Access Compliance Report

Public Rights-of-Way

Intersection ID: 26515	Main Street: JOHNSTON_RD	Cross Street: PORTERFIELD_RD	Location: SW
ADA ID: 12549E06216E	Ramp Type: PerpDiag	Initial Pass/Fail: Fail	Overall Compliance: No
			Severity Score: 21.25

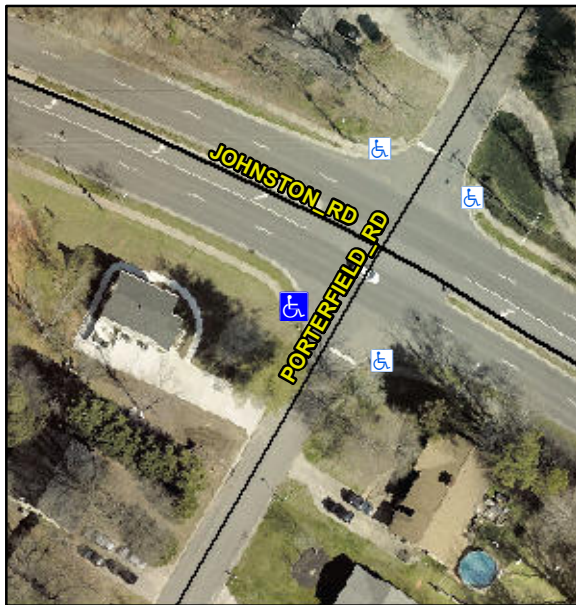
Not Found, R304.5.1, R304.2.2

Compliance	Description	Data	Compliance	Description	Data
N/A	Ramp Length (in)	59.0	No	Ramp Slope (%)	10.7
No	Ramp Width (in)	40.0	Yes	Ramp XSlope (%)	1.3
N/A	Flare Type LT	N/A	N/A	Flare Type RT	N/A
N/A	Flare Slope LT (%)	N/A	N/A	Flare Slope RT (%)	N/A
N/A	Flare Traversable LT?	N/A	N/A	Flare Traversable RT?	N/A
N/A	Landing Length (in)	N/A	N/A	DWS Provided?	N/A
N/A	Landing Width (in)	N/A	N/A	DWS Contrast?	N/A
N/A	Landing Slope (%)	N/A	N/A	DWS Length (in)	N/A
N/A	Landing X Slope (%)	N/A	N/A	DWS Full Width?	N/A
N/A	Landing Curb? (Y/N)	N/A	N/A	DWS Offset (in)	N/A
N/A	Shared Landing?	N/A			
N/A	Gutter Ponding?	N/A	N/A	Gutter Slope (%)	N/A
N/A	Gutter Lip Ht (in)	N/A	N/A	Gutter X Slope (%)	N/A
N/A	Painted X Walk1?	No	N/A	Painted X Walk2?	No
	X Walk 1 Direction	To SE		X Walk 2 Direction	To NE
N/A	X Walk 1 Width (in)	N/A	N/A	X Walk 2 Width (in)	N/A
	X Walk 1 Slope (%)	0.3		X Walk 2 Slope (%)	6.7
	X Walk 1 X Slope (%)	4.1		X Walk 2 X Slope (%)	3.1

Remove & Replace Curb Ramp With Two New Directional Ramps or Equivalent.
